Safety Evaluation Report for Shipment of Plutonium/Uranium Mixed Oxide in the Model 9975, Addendum, S-SARA-G-00015, Revision 2, April 2013

Docket No. 13-11-9975

Figure 1.2 Typical plastic bottle configuration within the PCV for shipping MOX content

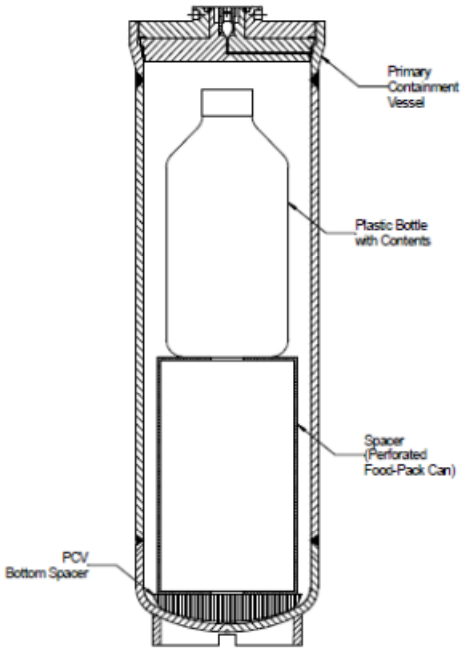
The Addendum lists three alternative conditions for controlling the generation of hydrogen during the shipment period and evaluates the use of the 9975 without the PCV Sleeve. Two of the conditions determine safe shipping periods of 6 days (Condition 1) or 45 days (Condition 2) by limiting the rates for gas generation. The third condition assumes the void spaces in the PCV (except for those in the plastic bottles) are inerted with nitrogen prior to closure of the PCV. It is assumed that for all three conditions, there is no hydrogen in the plastic bottles at the time of loading. Given the uncertainties associated with the amount of moisture content, plastic hydrogenous material and calculations of the shipping period, DOE PCP staff concluded that inerting the PCV, any plastic bagging and the plastic bottle is a required condition to ensure safety of shipping the MOX in plastic bottles; which excludes Conditions 1 and 2 from this review. Furthermore, Condition 3 is acceptable only if the void space in the plastic bottle is inerted with nitrogen at the time of closure of the PCV, and that there shall be adequate gas communication between the void space of the plastic bottle, any plastic bagging and the PCV (see Section 3 of this SER for additional details.)

"Addendum Conditions 1 and 2 are not authorized for use"

"The maximum amount of plastic materials in the PCV, including high-density polyethylene, low-density polyethylene, or polyvinyl chloride bottles, low-density polyethylene bagging, and polyvinyl chloride tape, shall be no more than 200 grams."
